## ADDENDUM NO. 1

May 29, 2025

Leggett Volunteer Fire Department & Town Hall  
29 Draughn Rd  
Tarboro NC 27886

- 1 – Pre-Bid Meeting Key Notes – Dated 05-15-2025
- 2 – Pre-Bid Meeting Sign-in Sheet – Dated 05-15-2029
- 3 – RFI Log – Dated 05-29-2025
- 4 – Revision 1 Sheets – Dated 05-15-2025
- 5 – Revision 2 Sheets – Dated 05-29-2025

Title Sheet: STAIR DETAILS - TRUCK BAYS  
Building One  
29 Draughn Rd, Tarboro, NC  
27886

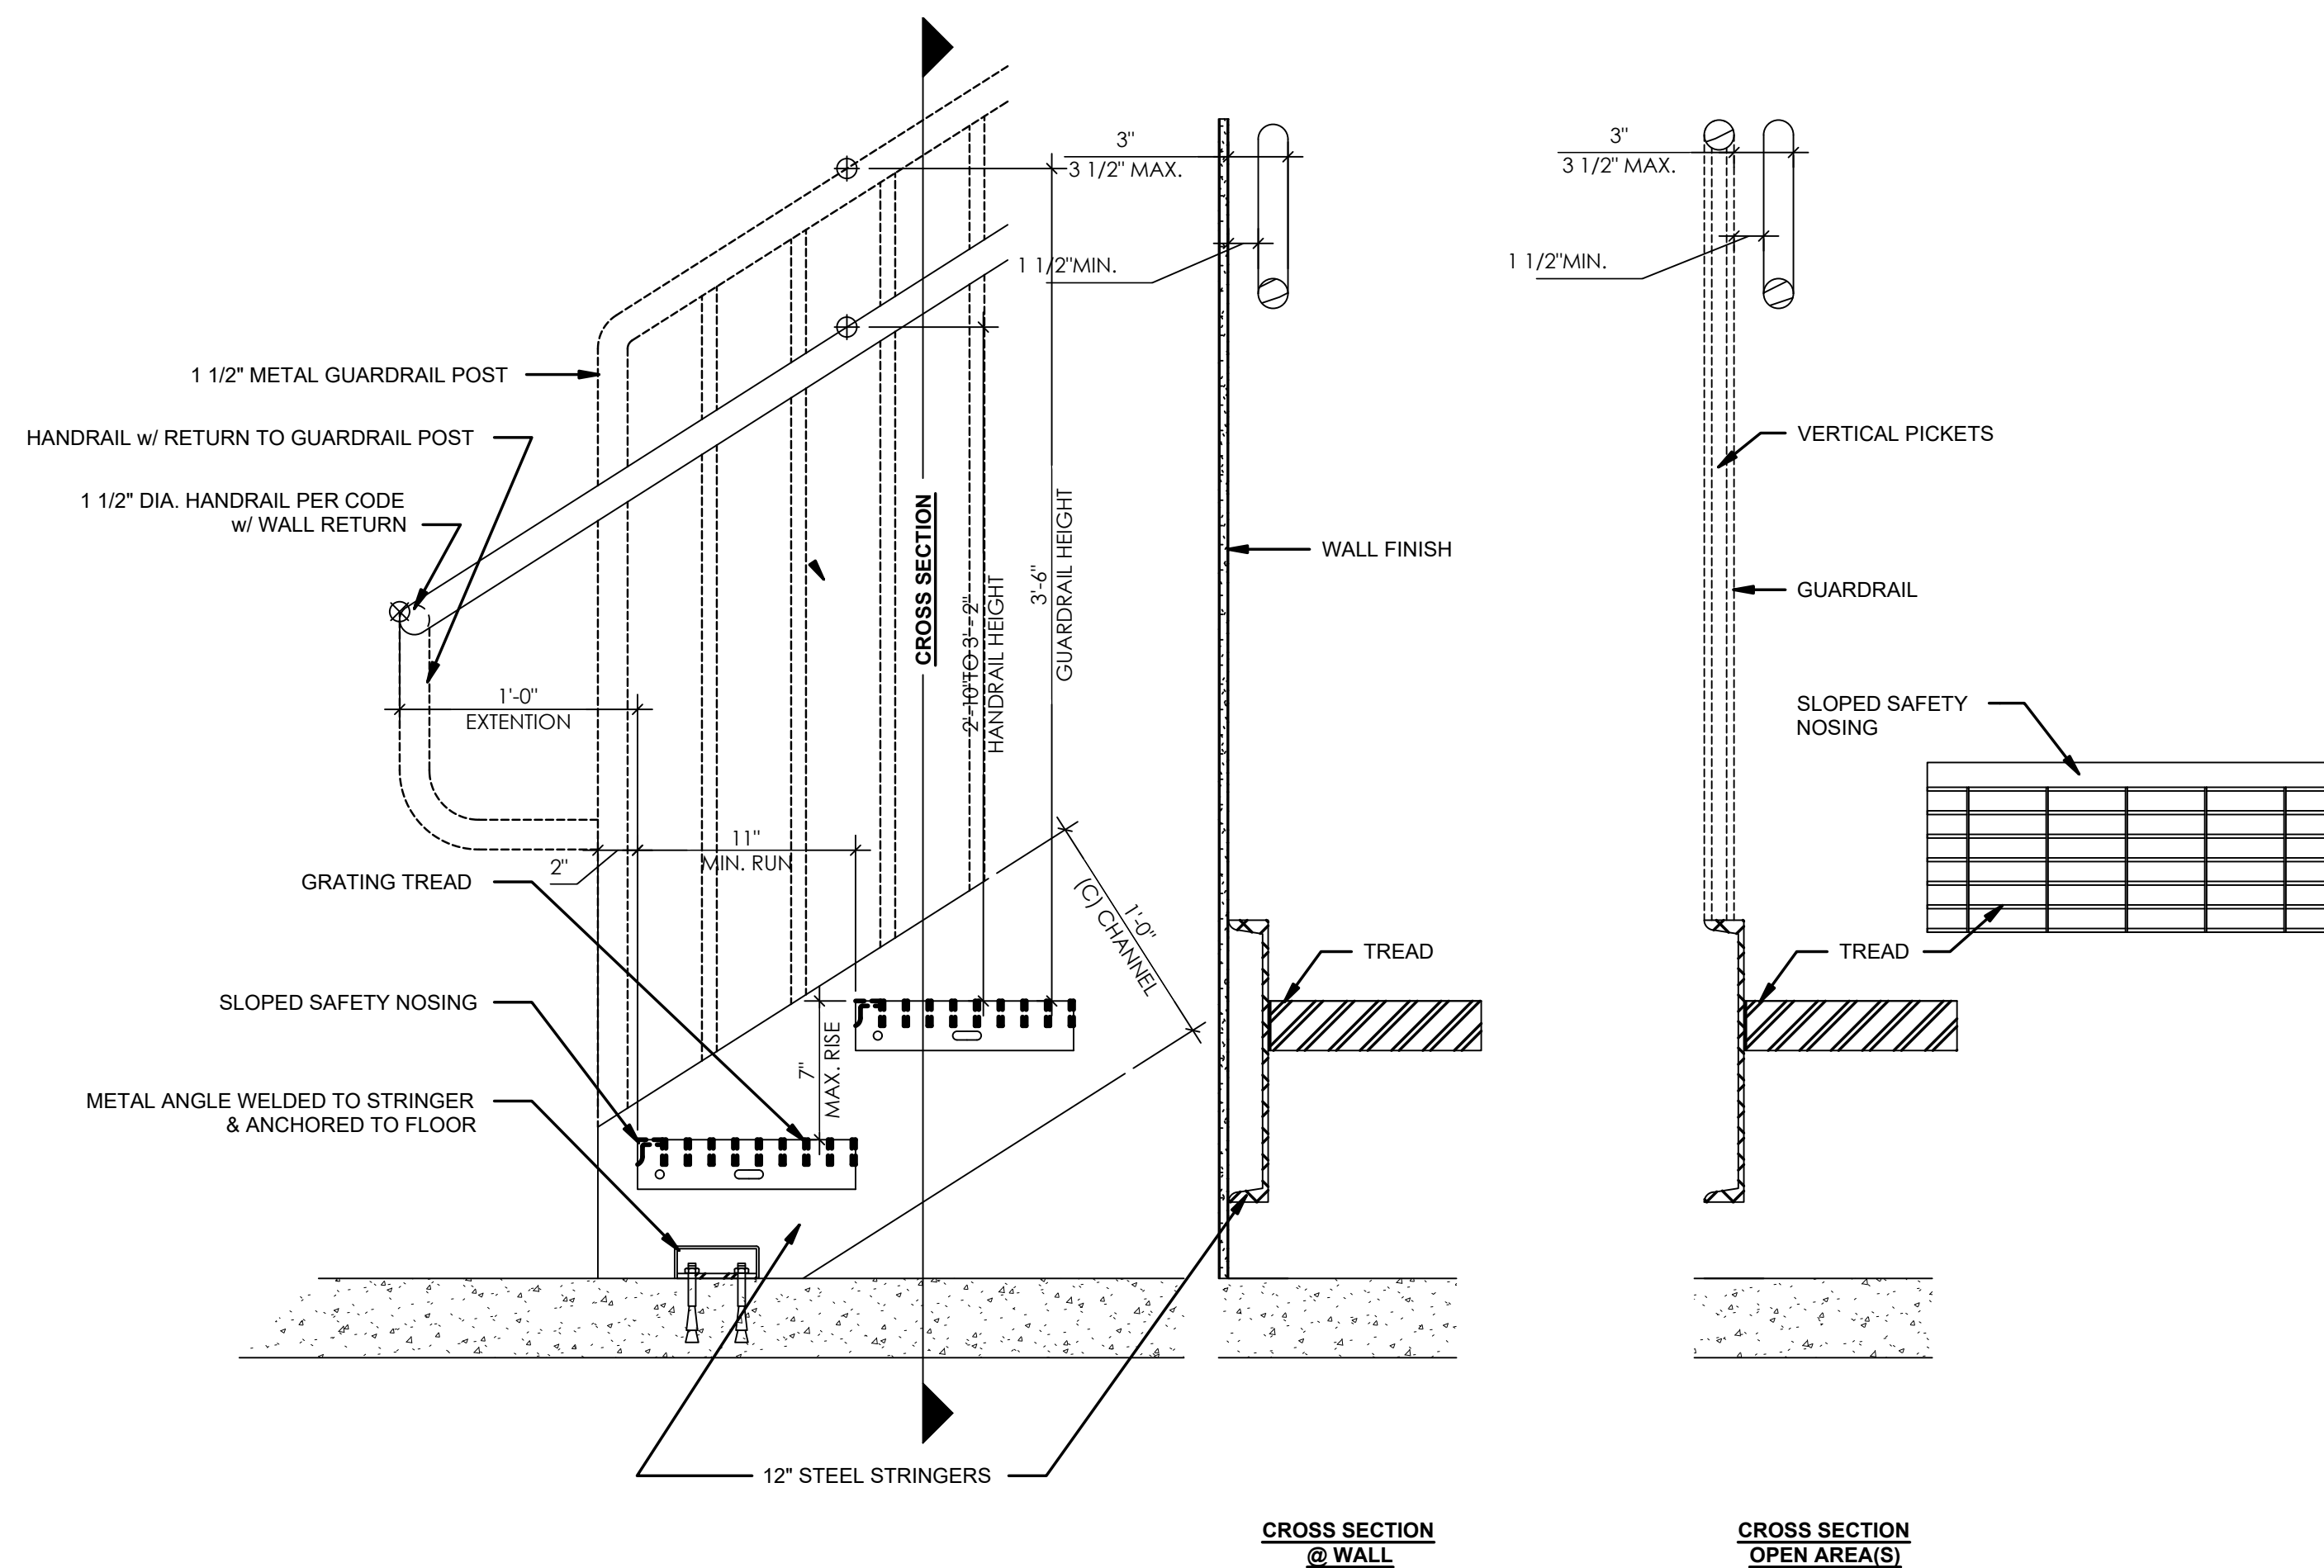
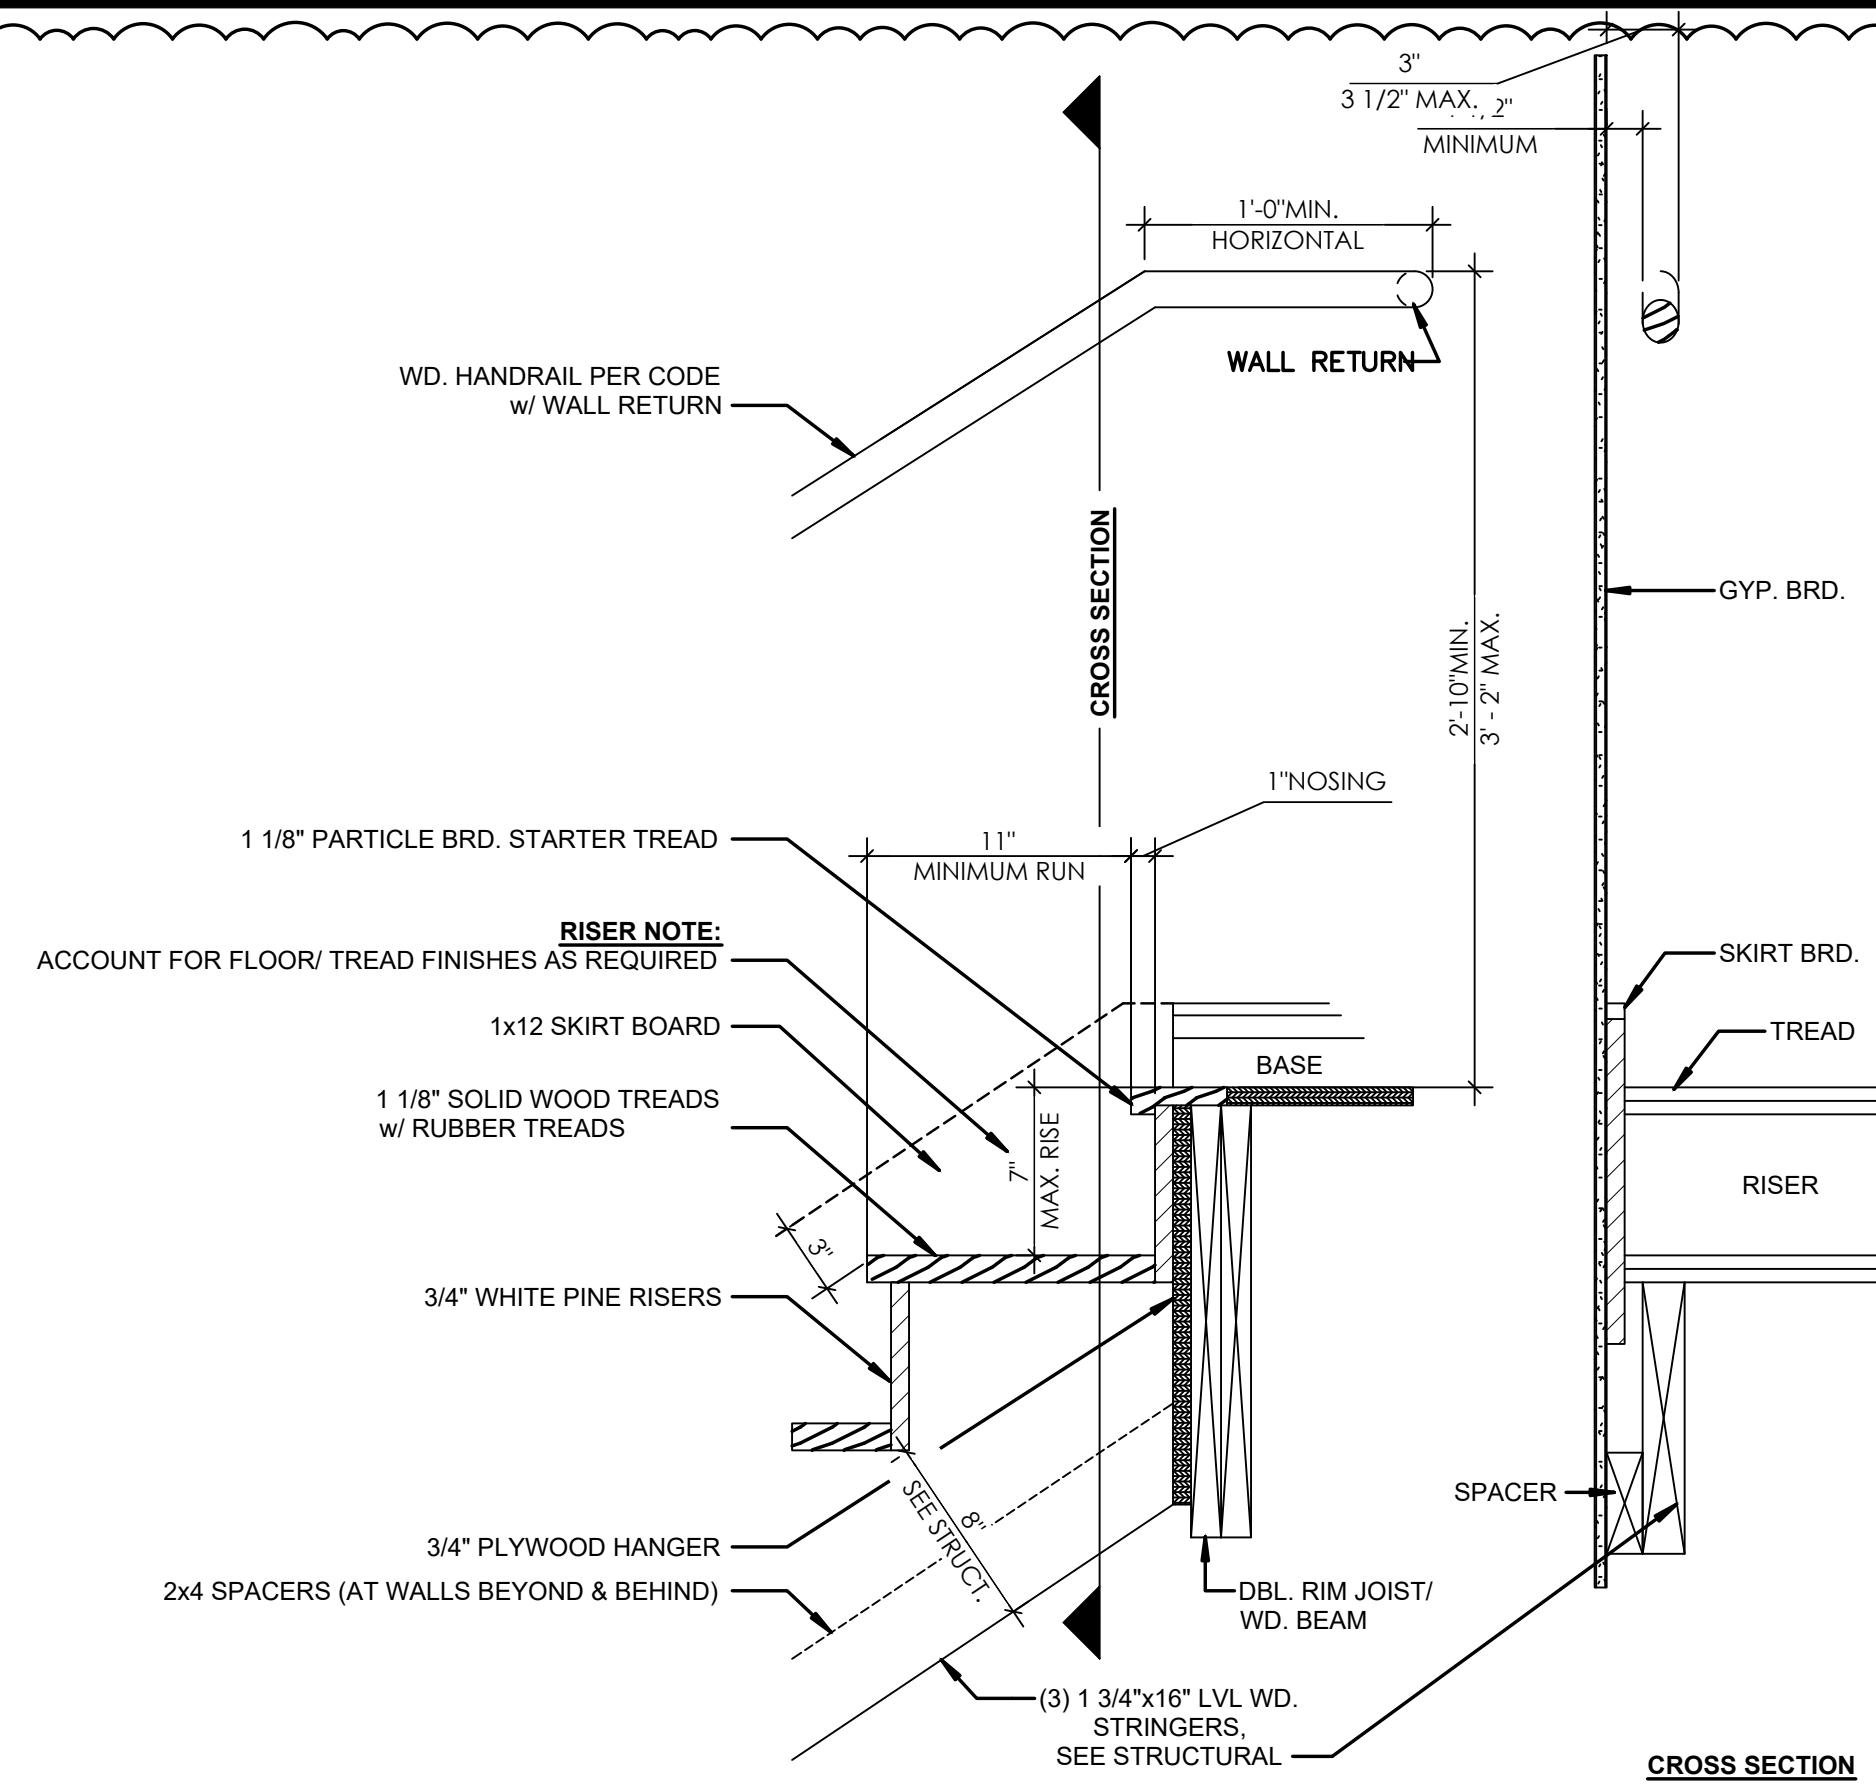
14	The interior stair shows an LVL stringer with concrete treads and the detail shows grated treads also. Can we figure that out as well.	Stairs in truck bay to be grated, interior stairs should be wood. See Revision 2 sheets.
15	The plans are locked to where I cannot scale them to figure out the channel size for the stairs. Please let me know if we can get that fixed.	We are unable to send out unverified plans.
16	Could the project schedule be extended to 13 or 14 months?	Project duration to be 13 months. If alternate no 2 is accepted, project to remain at 11 months.

ALL STAIR DETAILS ON THIS SHEET ARE FOR THE INTERIOR STAIRCASE LOCATED IN TRUCK BAY
